SERVICE PROCEDURE

**13519
FEBRUARY 2014**

SUBJECT: NON-COMPLIANCE RECALL
Driver seat belt buckle on certain AE, BE, CE, and RE school bus models built 8 August 2013 thru 14 November 2013 having certain IMMI seat belt assemblies with L9 end-release seat belt buckles

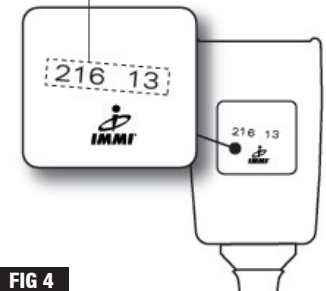
3. Find the buckle assembly date code on the back housing of the buckle. (FIG 3 and 4)
4. There are 2 different date code formats as illustrated below. (FIG 3 and 4)

Suspect code range is
214 13 through 256 13

DAY	YEAR
216	13

5. If your buckle code is within either of the ranges above, follow instructions to order, then replace the buckle.
6. If your code does NOT fall within either range, you do NOT need to replace your buckle.

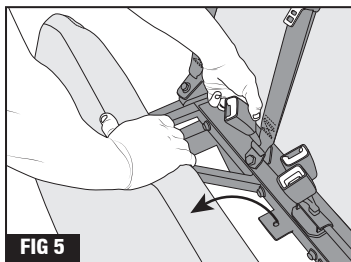
1. Unlatch seat cushion and pivot cushion up and forward. (FIG 5)
2. At this point the buckle attachment hardware will be accessible.
3. Before beginning removal of the seat belt buckle take care to **note the orientation of the seat belt buckle end fitting, bolts, nuts, and washers**. When installing the replacement buckle assembly the end fitting and hardware orientation must match the original configuration for proper performance.
4. Loosen and remove the fasteners for one buckle assembly at a time. Due to the locking patch on some of the fasteners they may seem very tight.

1. Reinstall by reusing the original hardware and the new replacement buckle assembly. Make sure you don't mix up the old and new buckle assembly.
2. Tighten bolts and nuts to 30-50 lb-ft. torque.
3. Repeat for the remaining buckle assemblies that require replacement.
4. All replaced L9 buckles must be returned.

39" Seat with 3 Lap-Shoulder Belts

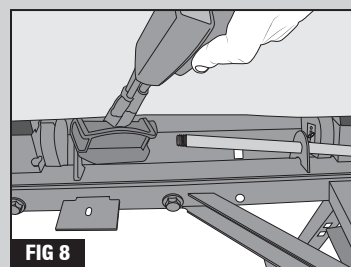
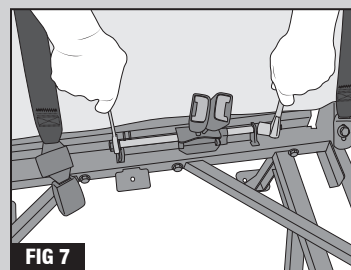
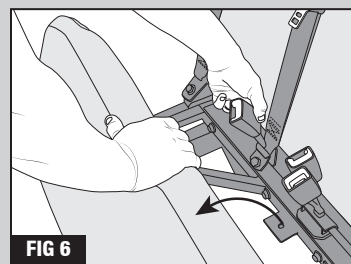
In the special case of a 39" seat with 3 lap-shoulder seat belts the replacement of the sliding double buckles is as follows:

1. Unlatch seat cushion and pivot cushion up and forward. (FIG 6)
2. Loosen and remove the nut on the end of the slider rod closest to the center of the seat. It may be necessary to grasp the rod with pliers or vise grips if the nut furthest from the center of the seat begins to loosen first. (FIG 7)
3. Slide the rod to the left (as seated in the seat) enough for the end near the center of the seat to clear the bracket. (FIG 8)
4. Tilt the rod enough to clear the bracket. (FIG 8)
5. Slide out the rod. (FIG 8)
6. Remove the two buckles.
7. Push the plastic sleeve out of the buckle slider assembly and remove old buckles.

1. Install new buckles and slide the sleeve back in place.
2. Reverse the disassembly instructions to replace the sliding buckle assembly on the seat.
3. Make sure the two nuts are fully threaded onto the rod and tighten the nuts snugly.
4. All replaced L9 buckles must be returned. IMMI Field Sales will provide an RMA number and instructions for shipping buckles back to IMMI.
